**PLANNED UNIT DEVELOPMENT  
& SUBDIVISION STAFF REPORT****Date: August 1, 2019**

| <b><u>DEVELOPMENT NAME</u></b>              | A & B Subdivision, Resubdivision of Lot 1   |
| <b><u>CONTEMPLATED USE</u></b>              | Planned Unit Development Approval to allow multiple buildings on a single building site, and subdivision approval to create one legal lot of record from an existing legal lot and a metes-and-bounds parcel. |

# DETAIL SITE PLAN

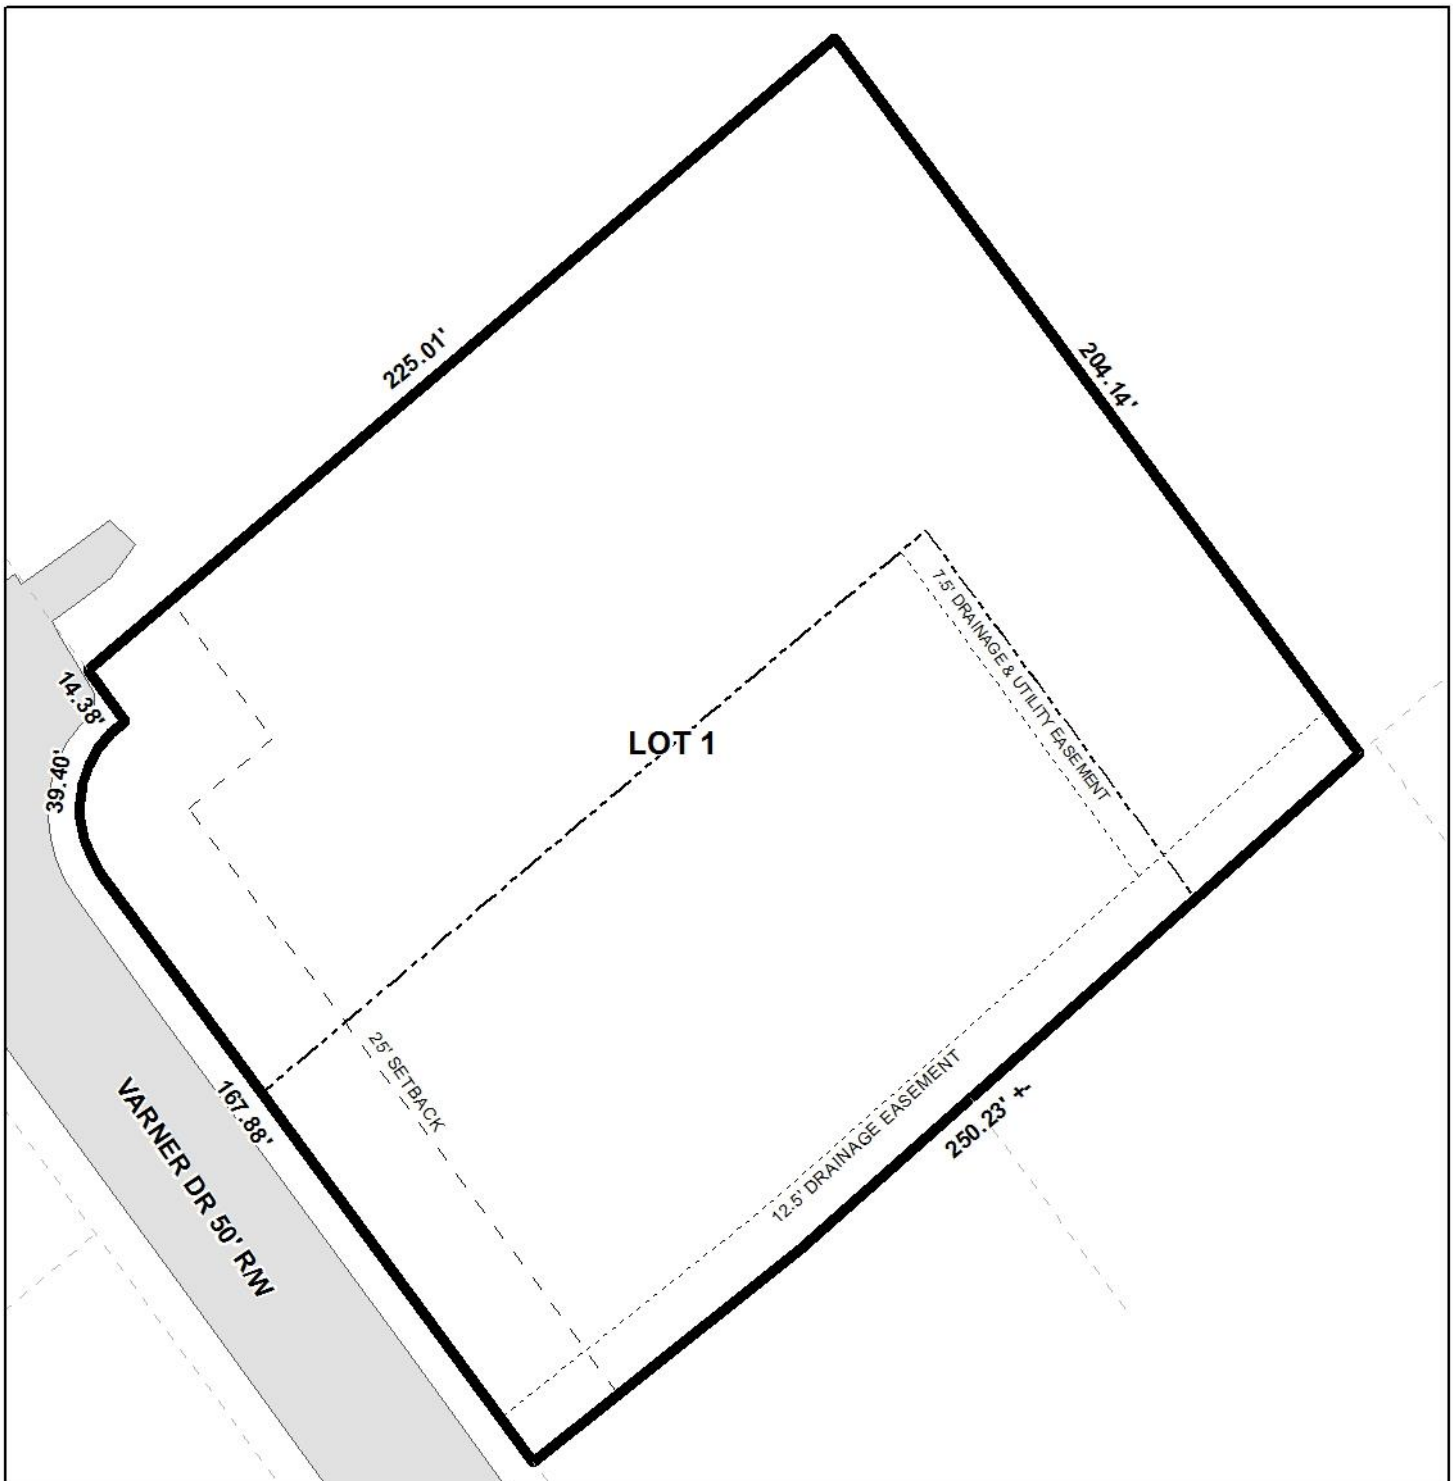
The preliminary plat depicts the lot size in both square feet and acres; however the site plan does not. The site plan should be revised to depict the lot size in square feet and acres or the provision of a chart depicting the same information is required.

Regarding parking, the applicant states that there will be no new employees associated with the new building. The existing business has 15 employees, and this is not anticipated to change. Parking is required at a ratio of 1 space per 300 square feet of office space, and 1 space per 3 warehouse employees. It would appear that 6 parking spaces are required for the office area, and 3 more for the warehouse employees. As these are required spaces, they must be paved in asphalt, concrete or a similar material. The site plan does not depict parking, thus it should be revised to depict required parking, including any accessible parking spaces.

The 25-foot minimum building setback line is depicted on the preliminary plat, but is not depicted on the PUD site plan. The PUD site plan should be revised to depict the 25' minimum building setback where the site abuts street frontage.

The site plan also depicts a note that addresses dumpster compliance; however there is no illustration of a dumpster on site. The PUD site plan should be revised to depict a compliant dumpster (pad and enclosure) as per Section 64-4.D.9 of the Zoning Ordinance.

The preliminary plat depicts a 12.5' drainage easement and an existing 7.5' drainage and utility easement; however the PUD site plan does not reflect the same information. The PUD site plan should be revised to depict all easements, and a note should be placed on both the site plan and the plat stating no structures shall be placed or constructed within any easements.

- 1) revision of the site plan to depict the lot size in square feet and acres or the provision of a chart depicting the same information;
- 2) revision of the site plan to depict 9 compliant parking spaces;

- 3) revision of the site plan to reflect full compliance with tree and landscaping compliance (due to the cumulative building additions resulting in a more than 50% increase in building size);

- 4) revision of the site plan to illustrate the total square footage of all structures, and the square footage that is designated for office space and storage/ warehouse

- 5) revision of the site plan to depict the 25-foot minimum building setback line Varner Drive;
- 6) revision of the site plan to depict a dumpster in compliance with Section 64-4.D.9 of the Zoning Ordinance;

- 7) any new barbed-wire or similar fencing to be appropriately permitted;
- 8) placement of a note on the site plan stating no structures shall be placed or constructed within any easements;

- 9) revision of the site plan to depict the 12.5' drainage easement and an existing 7.5' drainage and utility easement;
- 10) compliance with Engineering comments: *"1. The proposed building will be addressed as 1643 Varner Dr. with a Unit Number (i.e. 1, A). Please contact the Engineering Department (208-6216) to discuss the options. 2. Label the SITE PLAN sheet (C1.0) as "PUD SITE PLAN". 3. ADD THE FOLLOWING NOTE TO THE PUD SITE PLAN: a. Any existing or proposed detention facility shall be maintained as it was constructed and approved. The Land Disturbance Permit application for any proposed construction includes a requirement of a Maintenance and Inspection Plan (signed and notarized by the Owner) for the detention facility. This Plan shall run with the land and be recorded in the County Probate Office prior to the Engineering Department issuing their approval for a Final Certificate of Occupancy.";*
